### **Addendum 43: Regulation No. 44**

#### **Revision 1 - Amendment 1**

Supplement 2 to the 03 series of amendments: Date of entry into force: 18 November 1999

**~~UNIFORM PROVISIONS CONCERNING THE APPROVAL OF RESTRAINING DEVICES FOR CHILD OCCUPANTS OF POWER-DRIVEN  
VEHICLES ("CHILD RESTRAINT SYSTEM")~~**

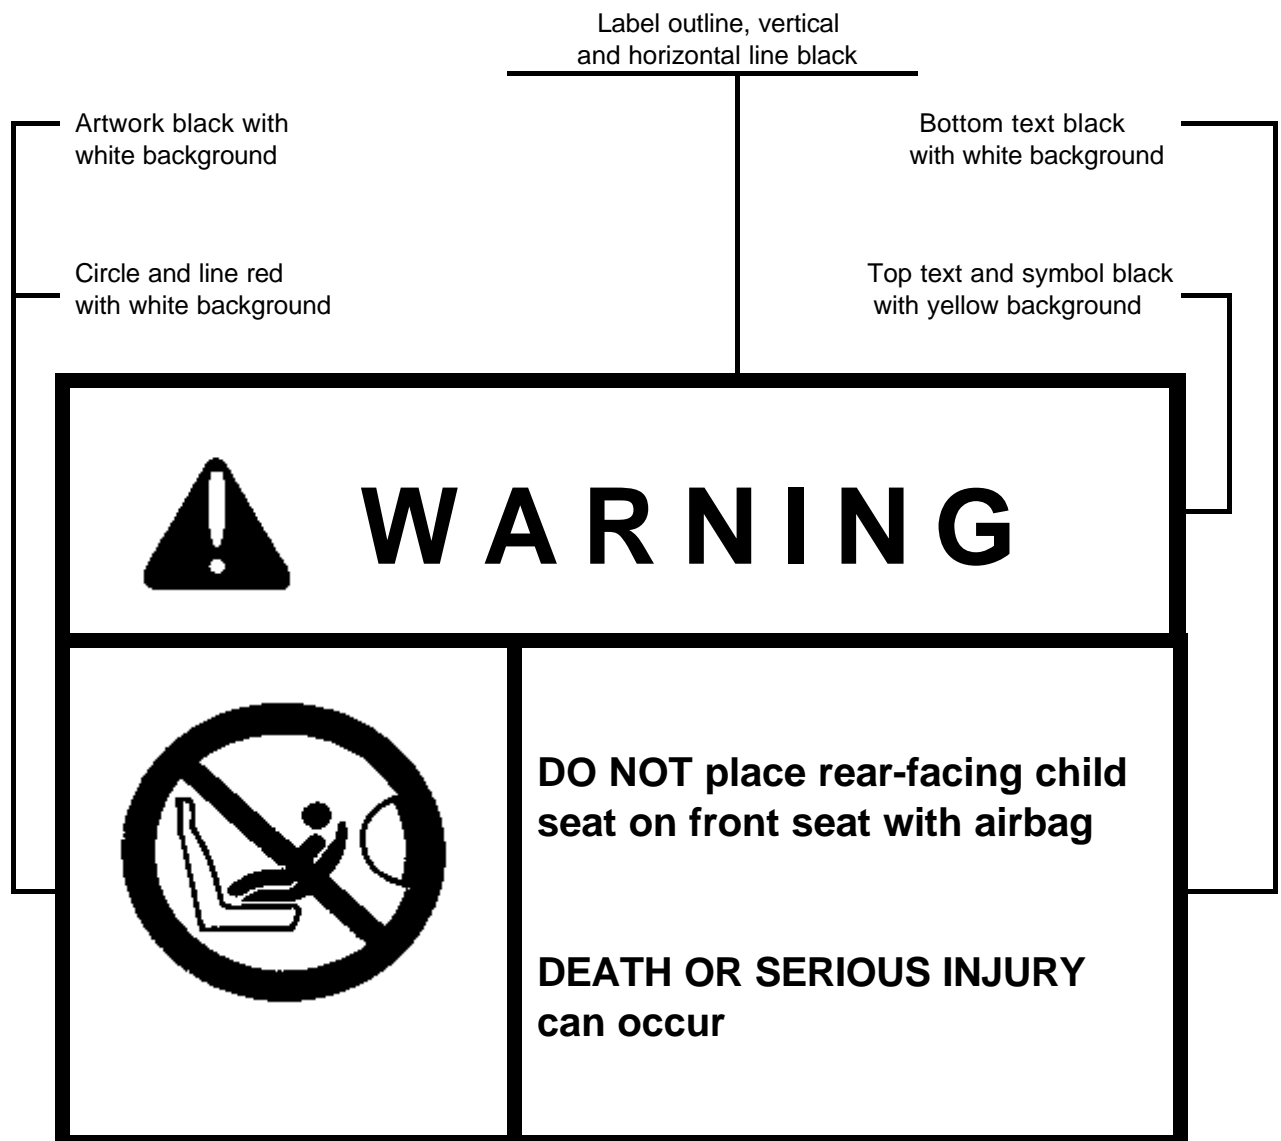
Insert a new paragraph 4.5., to read:

"4.5. In addition, in the immediate area where the child's head rests within the child restraint and on the visible surface of the child restraint system, rearward-facing restraints shall have the following label permanently attached (the text information shown is a minimum).

This label shall be provided in the language(s) of the country where the device is sold.

Label minimum size: 60 x 120 mm
